PLANNING BOARD MEETING AGENDA

February 26, 2025 at 7:30 PM

Re: 41 Glenbrook Road
Site Inspection for Potential Wetlands Buffer Encroachment

MEMORANDUM

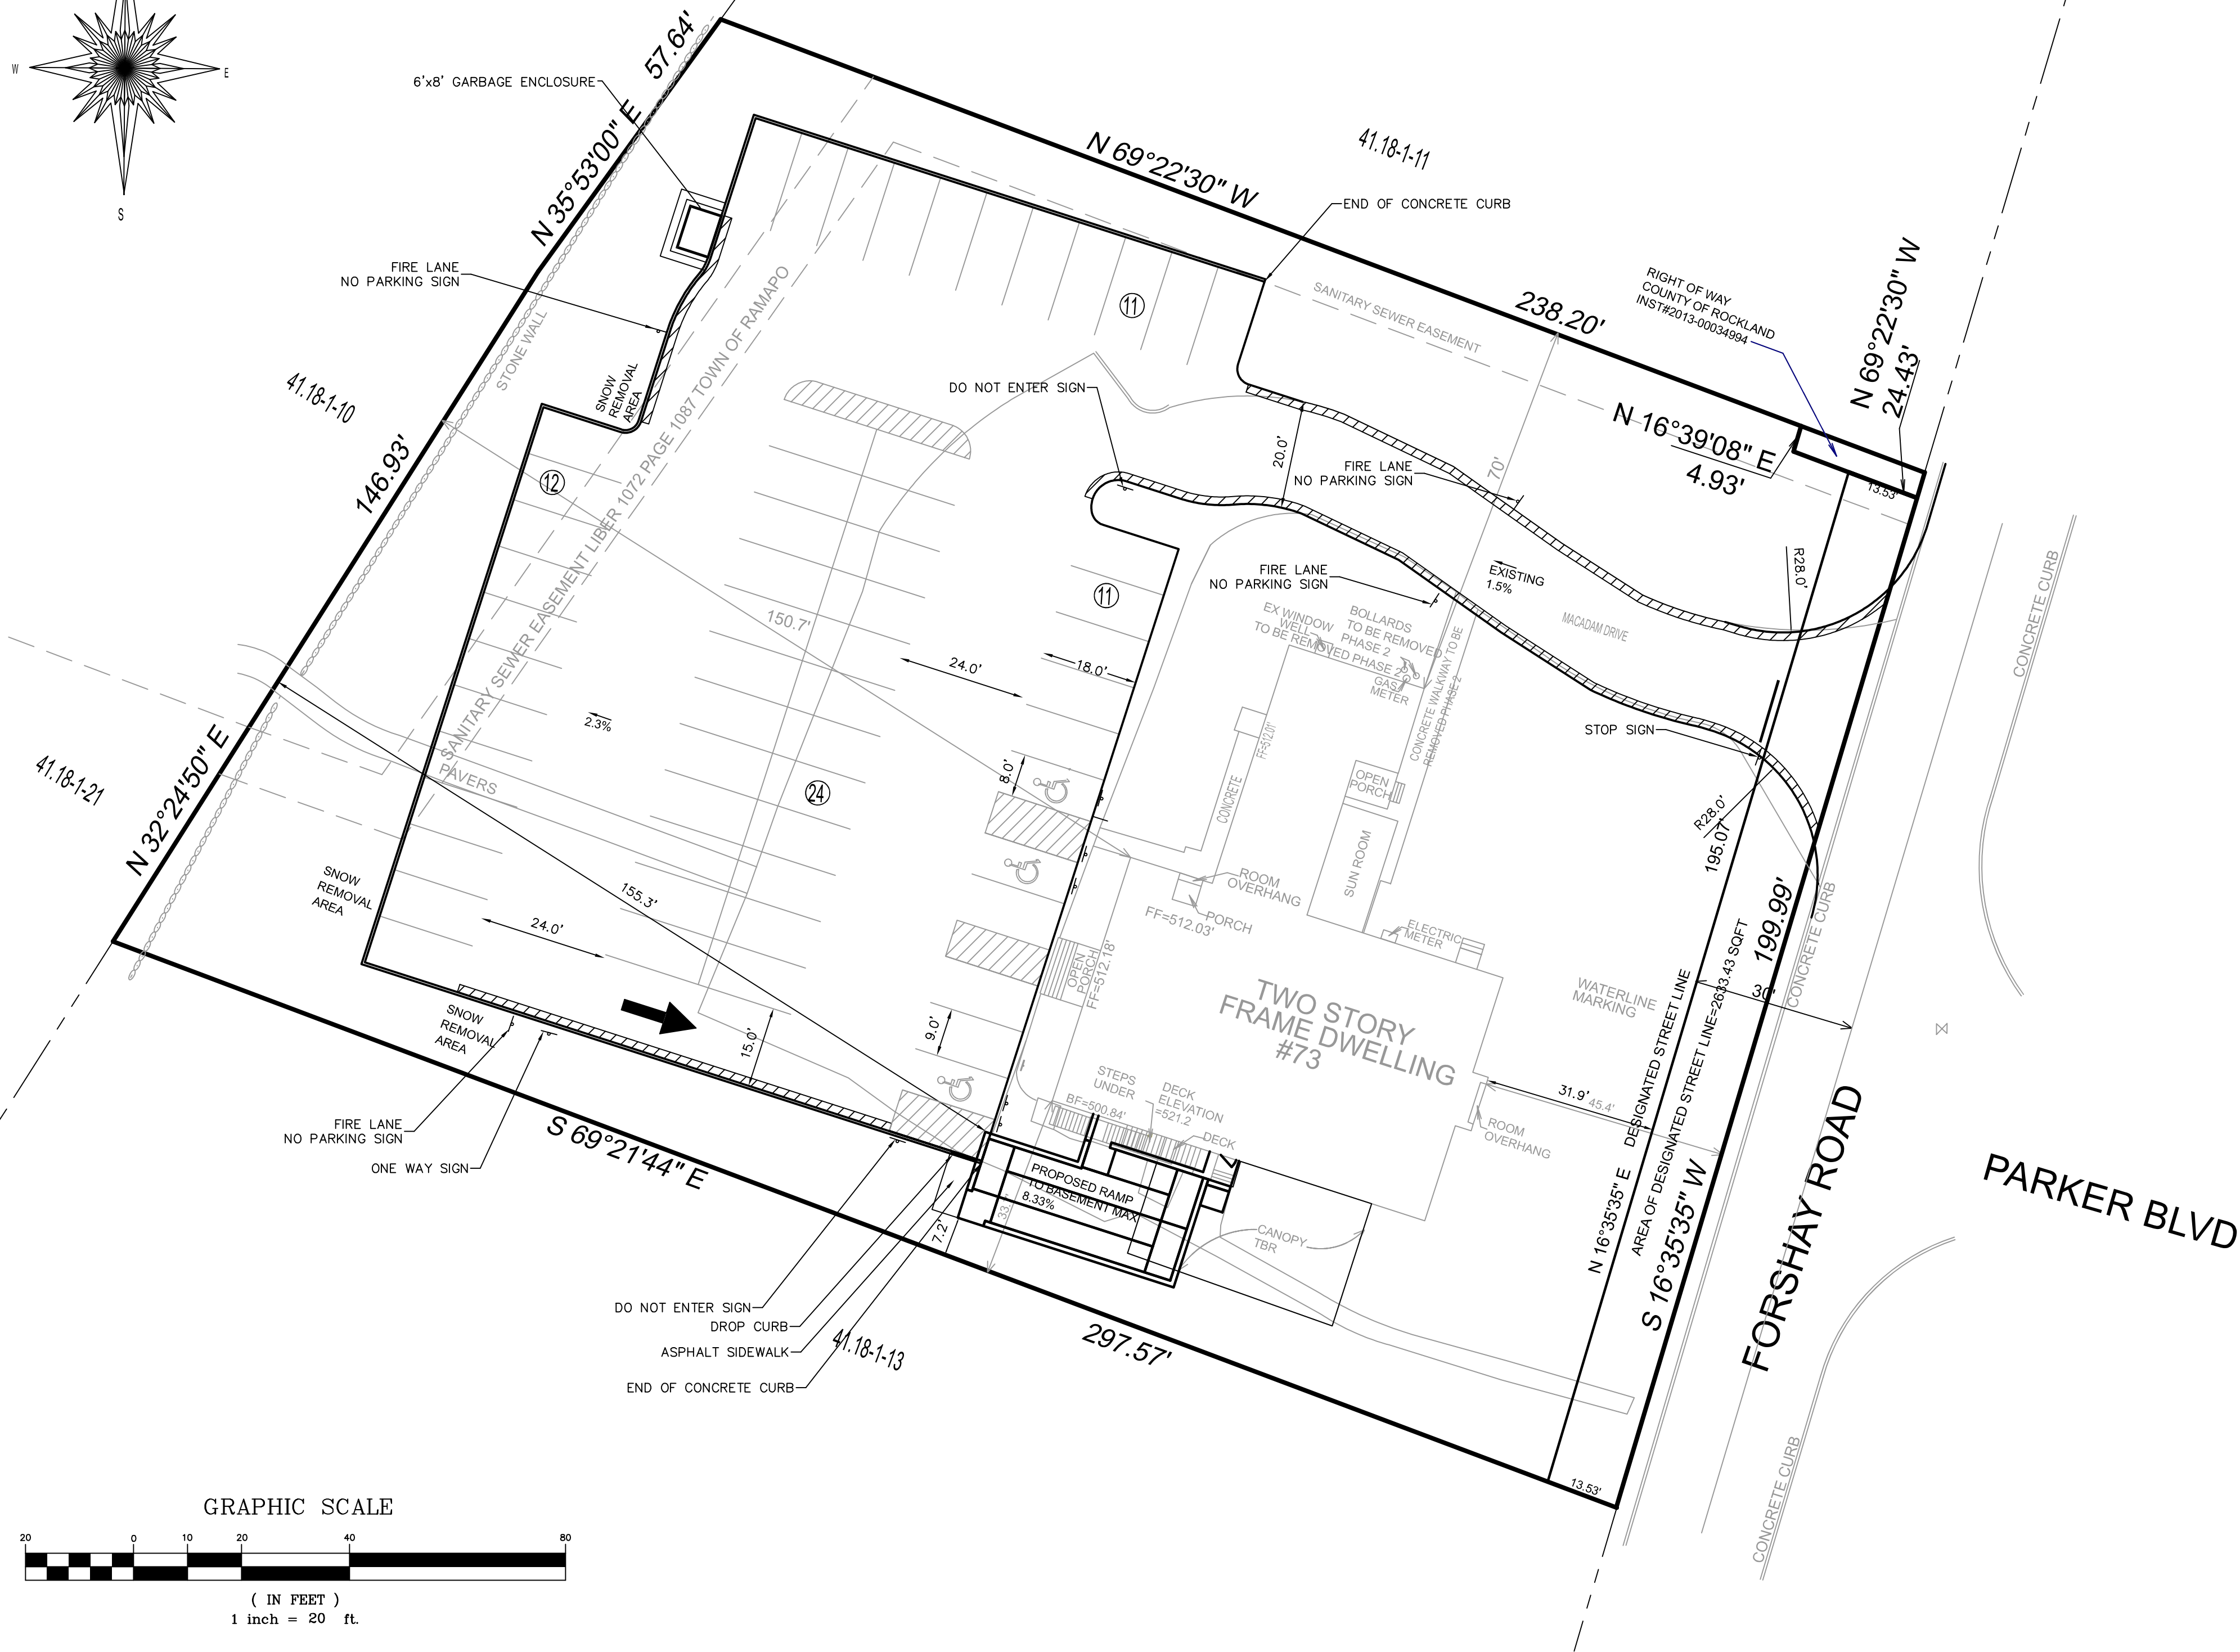
2. **It is unclear whether the proposed at-grade access walkway in front of the building will be constructed in Phase 1 or 2 as it is shown in both phases on Sheets 1 and 5. Please clarify exactly what items will be constructed in each phase.** The walkway is now only shown for phase 2.

6. **Please provide a Table of Dimensional Requirements Table for both sheets 1 and 5. Each table should have different values, corresponding to the construction proposed in each phase. For instance, each table for each phase should show different values for the maximum impervious surface ratio, to reflect changes between phase 1 and phase 2 of the project, when the building footprint will be increased. Separate bulk tables are now provided for phase 1 and phase 2.**

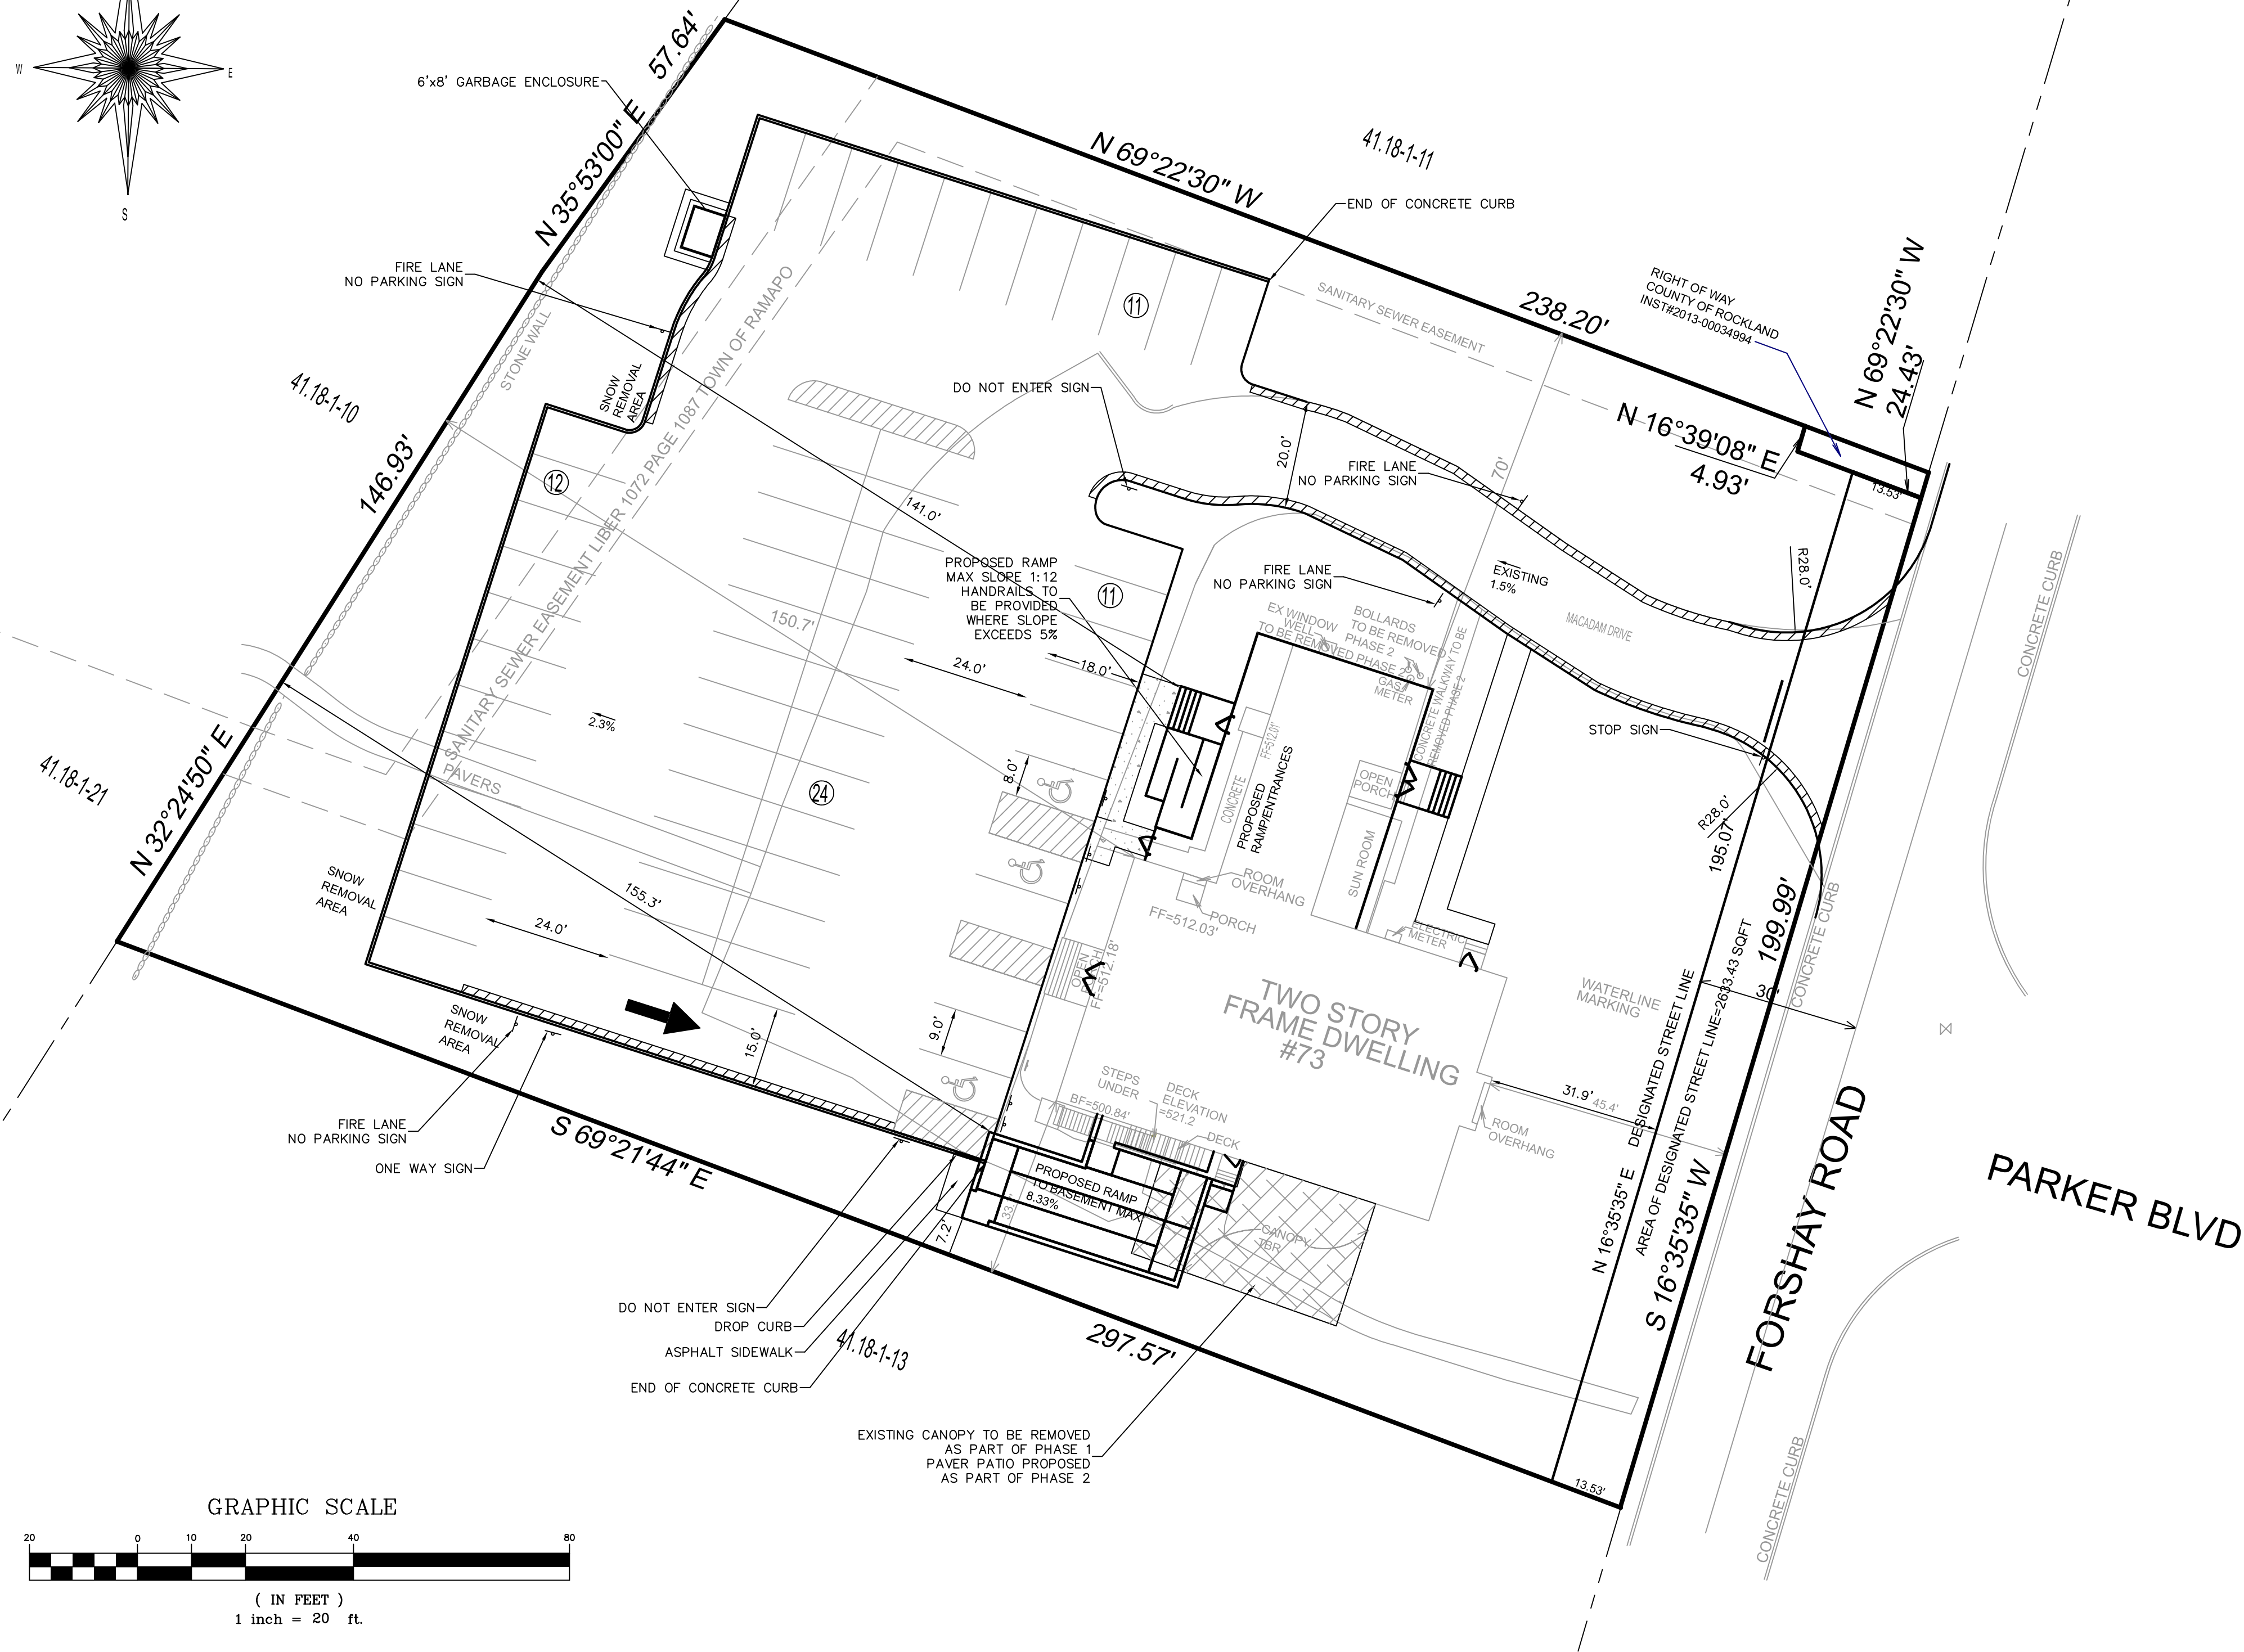
11. **To help reduce the impact of this development, a reduction of impervious surface should be considered. The amended Site Plan Phase 2 (Drawing 5 of 9) indicates that pervious pavers are proposed to be used for a patio at the southern side of the structure. It is recommended that porous pavers or porous concrete be considered to replace the use of conventional asphalt in additional areas of the site, as well. If installed correctly and properly maintained porous pavers have been shown to be effective in helping manage off-site runoff of stormwater. In addition to permeable pavers, other green infrastructure techniques should be considered such as bioswales, rain gardens, and rainwater capture. For long term effectiveness of permeable pavers and other green infrastructure techniques it is recommended that the Village and the applicant review Chapter 5 'Green Infrastructure Practices' of the 2015 NYSDEC Stormwater Design Manual. Based on the ground water, pervious pavers are no longer proposed.**
